FPL Energy
Seabrook Station

Seabrook Station
License Amendment Request 04-05
"Changes to Spent Fuel Assembly Storage Technical Specifications"

**Facility Operating License NPF-86
Docket No. 50-443**

**License Amendment Request 04-05,
"Changes to Spent Fuel Assembly Storage Technical Specifications"**

Figure 3.9-1
Fuel Assembly Burnup vs. Initial Enrichment
For Fuel Assemblies in BORAL Storage

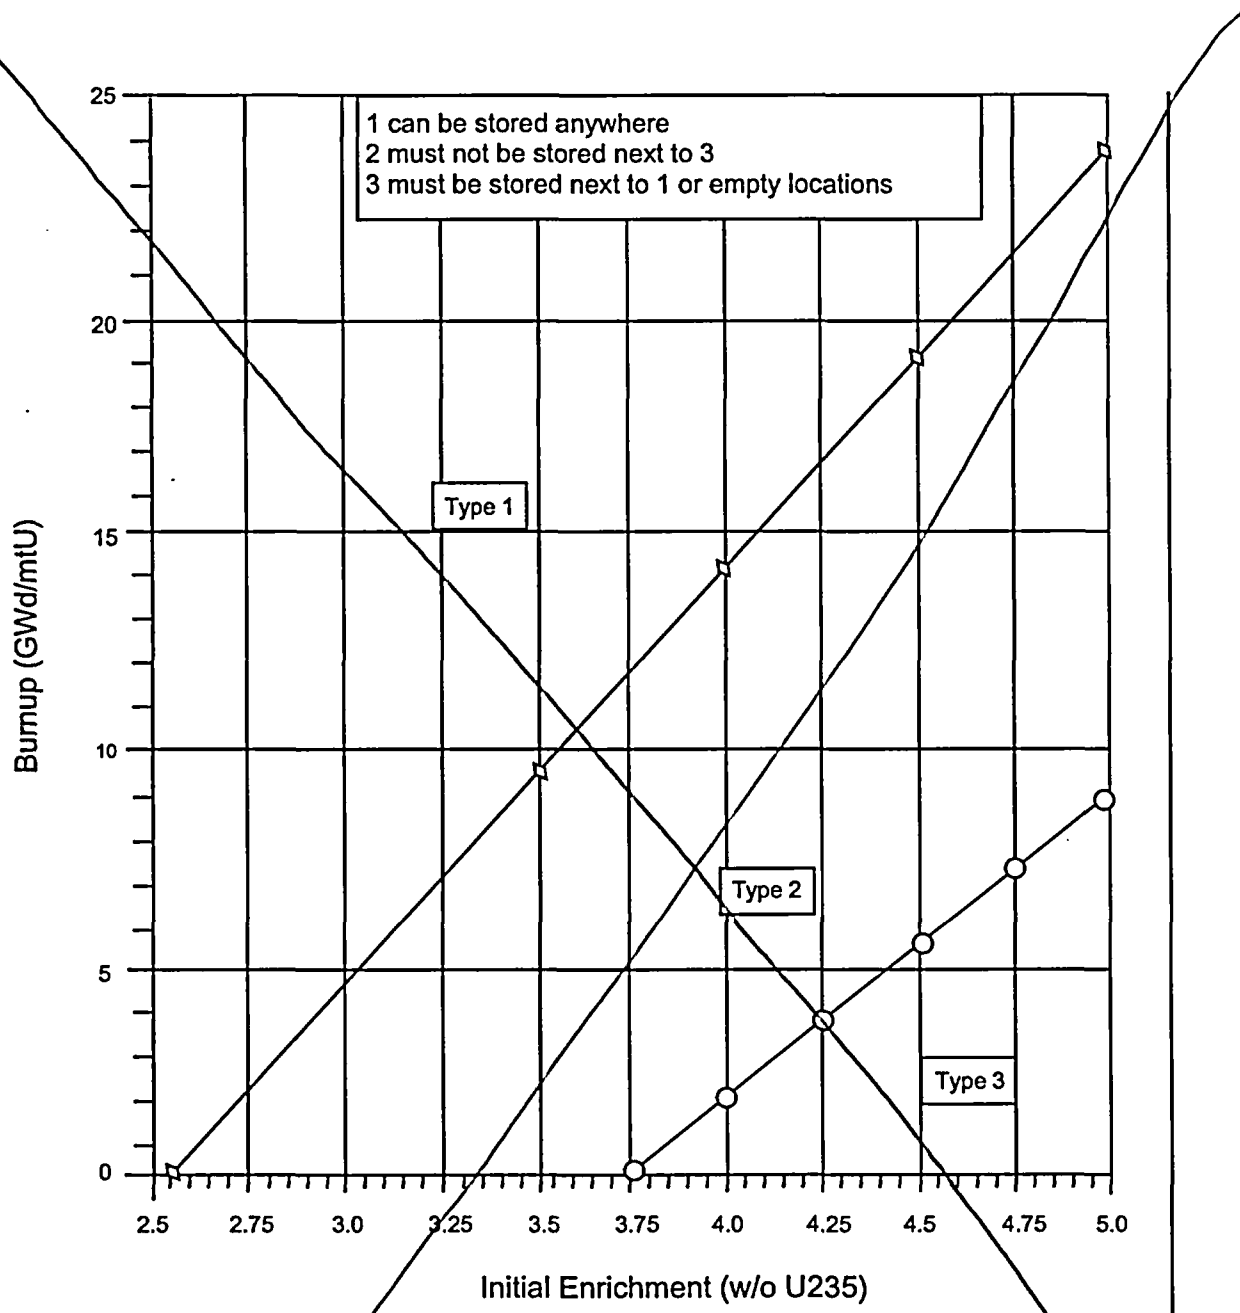
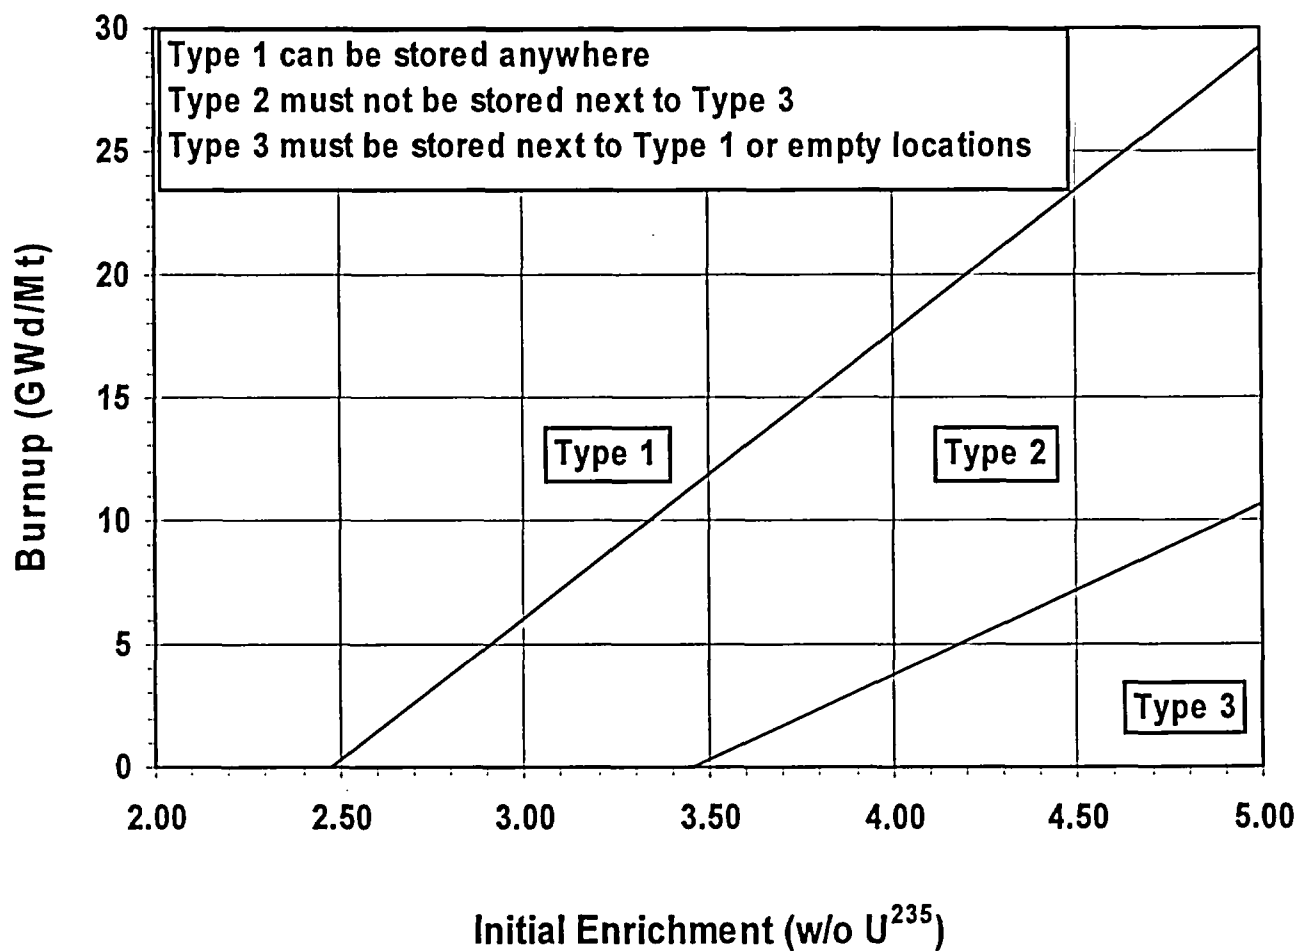
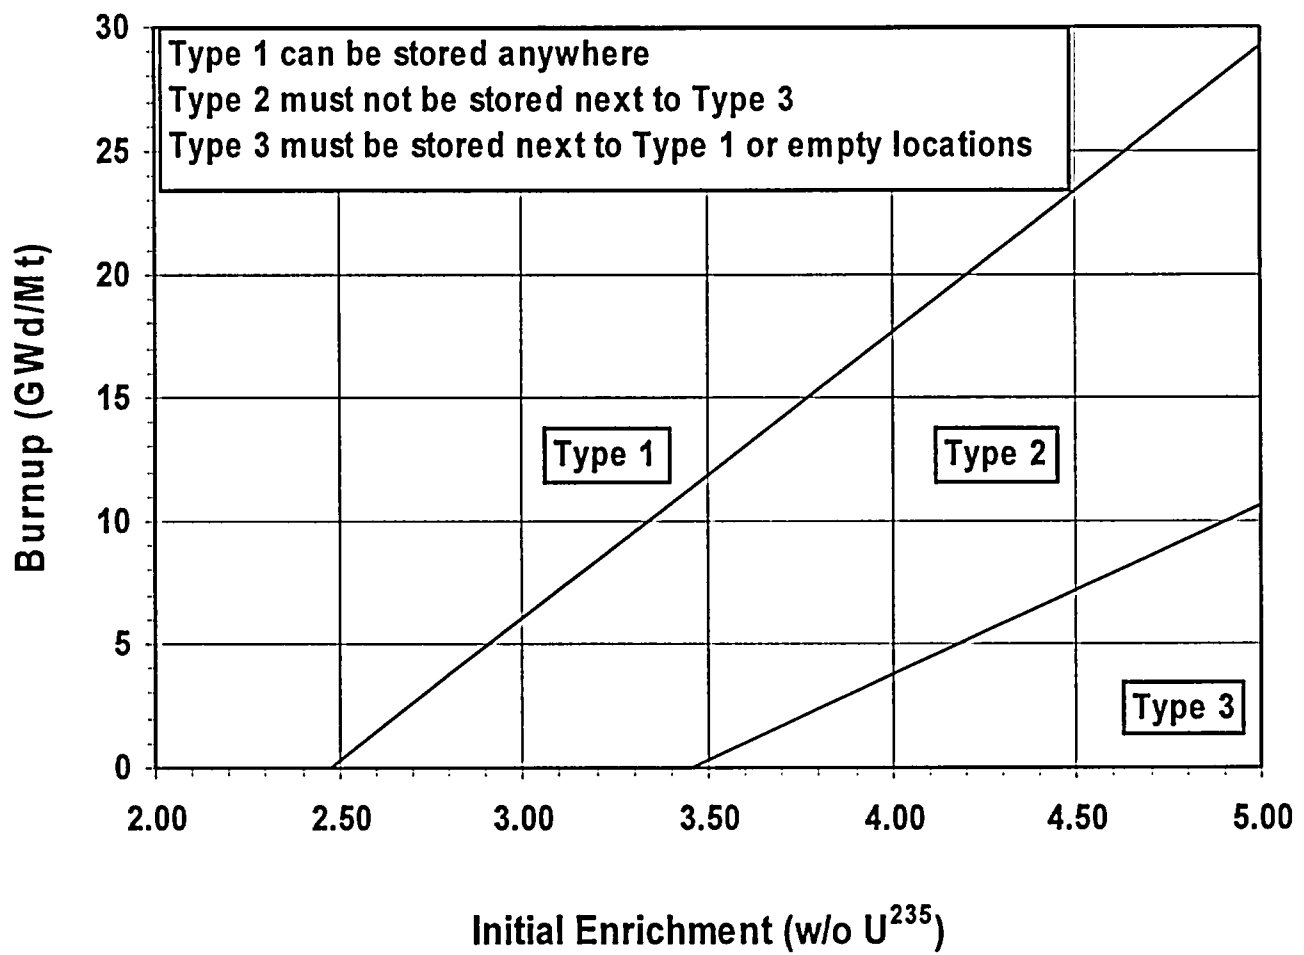
This change incorporates into TS 3/4.9.13, Spent Fuel Assembly Storage, the results of a revised criticality analysis for the spent fuel pool. Existing TS Figure 3.9-1, Fuel Assembly Burnup vs. Initial Enrichment for Spent Fuel Assembly Storage, has been modified and will control the storage of spent fuel in the BORAL[®] storage racks. New figure 3.9-2 has been added to control the placement of spent fuel in the BORAFLEX[®] storage racks.

The results of the above analyses were used to develop the proposed Technical Specification loading curves (i.e., proposed TS Figures 3.9-1 and 3.9-2 for the BORAL[®] and BORAFLEX[®] Zones, respectively).
